Access Compliance Report

Public Rights-of-Way

(Curb Ramps)

Intersection ID: 19122	Main Street: AMRITA_CT	Cross Street: RANDOLPH_RD	Location: NE
ADA ID: DEF1D27C98B4	Ramp Type: Directional1	Initial Pass/Fail: Fail	Overall Compliance: No
Severity Score: 13.75			
Codes/Mitigation Info/Possible Solution		Field Measurements/Component Compliance

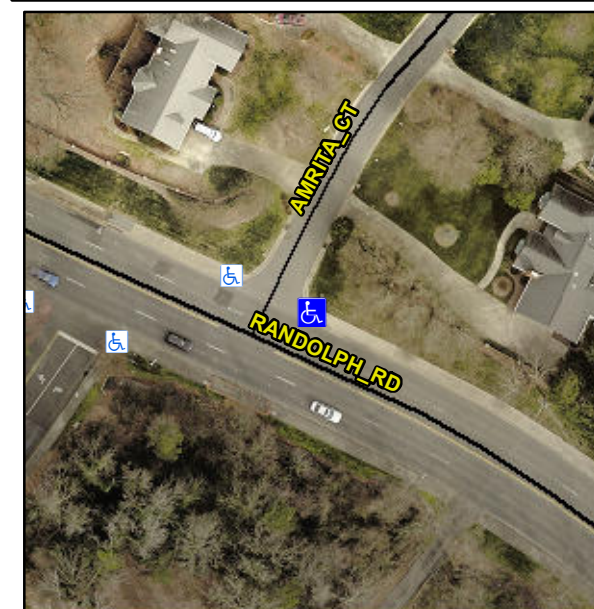
R304.2.2, R304.5.3

Compliance	Description	Data	Compliance	Description	Data
N/A	Ramp Length (in)	40.0	N/A	Grade Break?	N/A
Yes	Ramp Width (in)	51.0	N/A	Grade Break Slope (%)	0.0
No	Ramp Slope (%)	10.5	N/A	Grade Break XSlope (%)	0.0
No	Ramp XSlope (%)	2.9			
N/A	Flare Type LT	N/A	N/A	Flare Type RT	N/A
N/A	Flare Slope LT (%)	N/A	N/A	Flare Slope RT (%)	0.0
N/A	Flare Traversable LT?	N/A	N/A	Flare Traversable RT?	N/A
N/A	Landing Length (in)	0.0	N/A	DWS Provided?	N/A
N/A	Landing Width (in)	0.0	N/A	DWS Contrast?	N/A
N/A	Landing Slope (%)	0.0	N/A	DWS Length (in)	N/A
N/A	Landing X Slope (%)	0.0	N/A	DWS Full Width?	N/A
N/A	Landing Curb? (Y/N)	N/A	N/A	DWS Offset LT (in)	N/A
N/A	Shared Landing?	N/A	N/A	DWS Offset RT (in)	N/A
N/A	Gutter Ponding?	0.0	N/A	Gutter Slope (%)	N/A
N/A	Gutter Lip Ht (in)	0.0	N/A	Gutter X Slope (%)	N/A
N/A	Painted X Walk1?	No		Road Slope (%)	1.1
	X Walk 1 Direction	To W		Road X Slope (%)	6.1
	X Walk 1 Width (in)	N/A		Clear Space?	N/A

Remove & Replace Entire Ramp.
